IREDELL COUNTY HEALTH DEPARTMENT

IMPROVEMENT PERMIT / AUTHORIZATION TO CONSTRUCT / OPERATION PERMIT / EXISTING SYSTEM

APPLICANT: Rollans Soil/Pinnacle Building APPLICANT ADDRESS: 128-B Promenade Dr. Mooresville, NC 28117

SITE ADDRESS: 2585 Brawley School Rd Mooresville, NC PHONE: 704 746-5046 ALT. PHONE: 704 799-8641

INITIAL SITE SKETCH

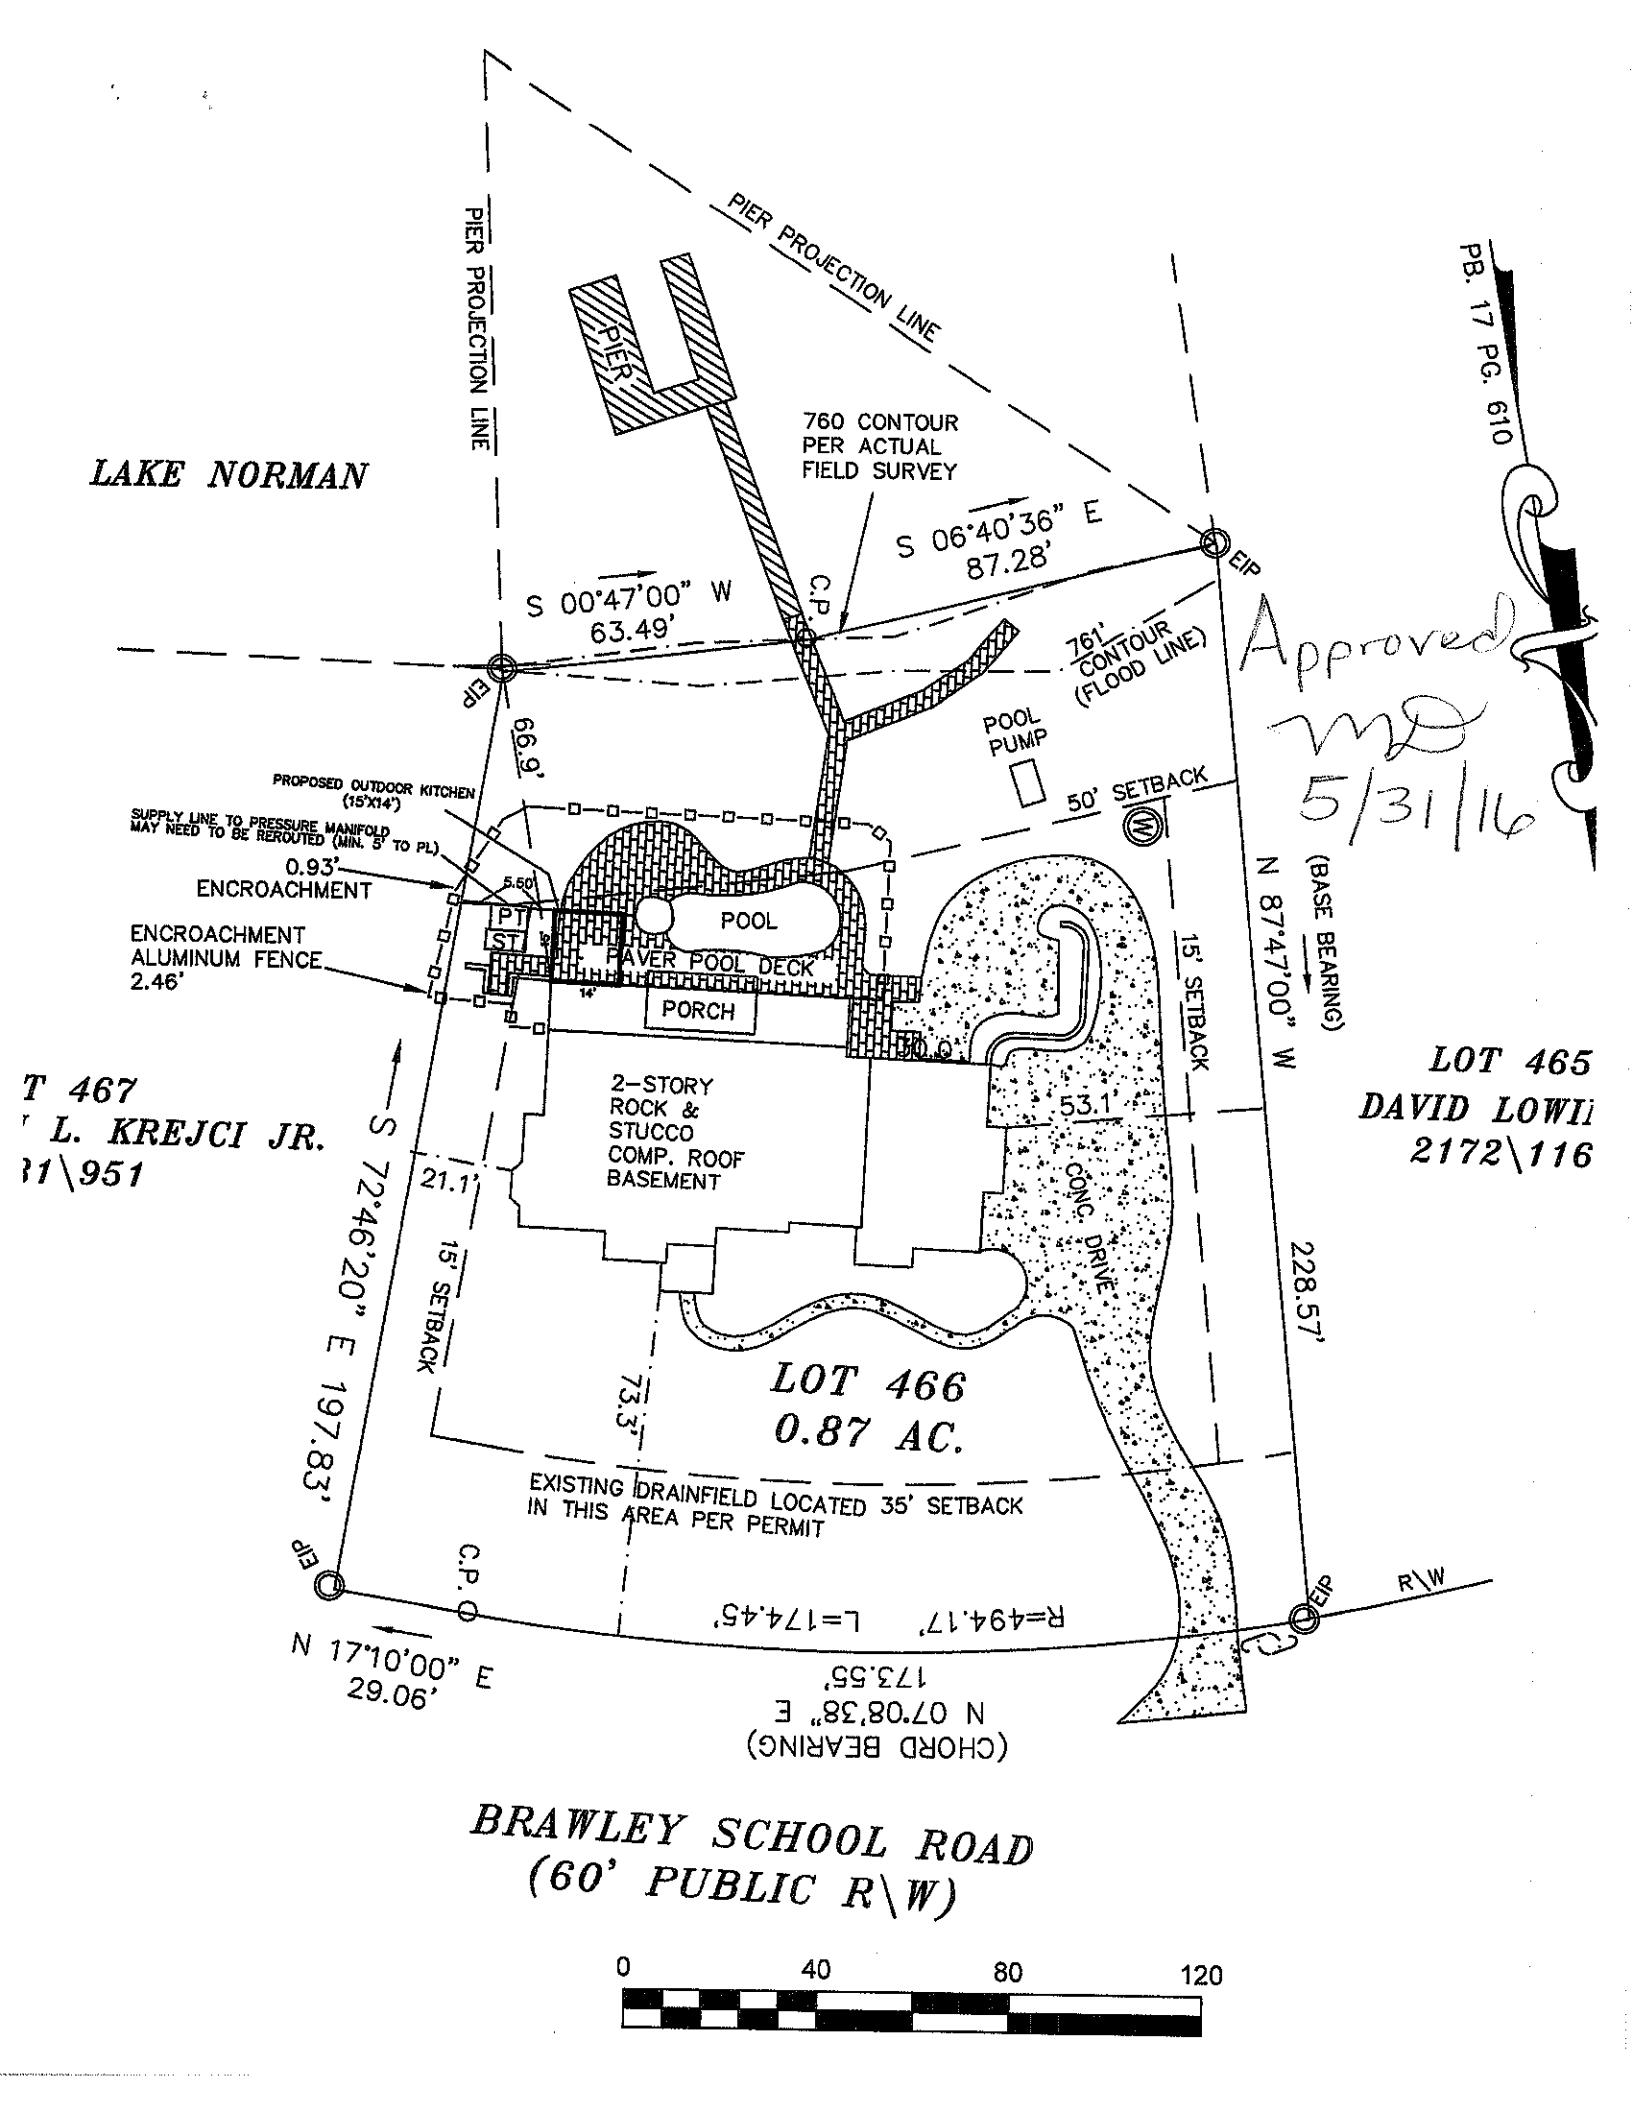
Comments / Conditions: The proposed Outdoor Kitchen does not impact existing Septic. Must maintain at least 5ft setback.
